Service Bulletin

BKSB-1017
Issue Date 7-7-03

Issue: No Tx audio when using LAA0258 desktop microphone.

Affected Models: LAA0258 Microphone when used with GBH-01 desktop base station with LZA 2027 Tone Termination Panel purchased prior to March 31, 2003.

Figure 1

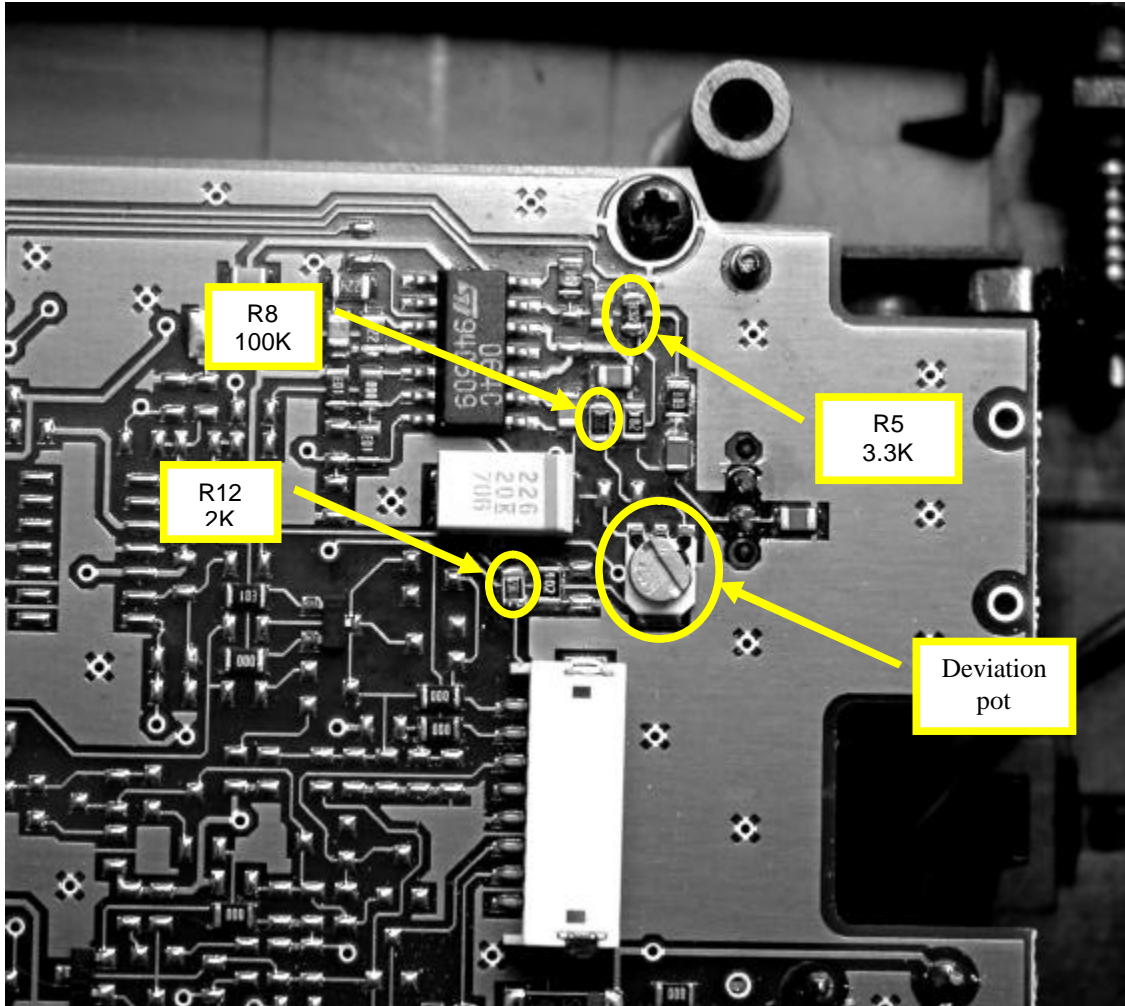
For steps 3 thru 6 see Fig. 1 for parts placement

3. Replace R5 with 3.3K ohms (RELM p/n = 4724-00332-223)
4. Replace R8 with 100K ohms (RELM p/n = 4724-00104-223)
5. Replace R12 with 2K ohms (RELM p/n = 4724-00202-223)
6. Readjust deviation potentiometer as necessary.
7. Reassemble Microphone
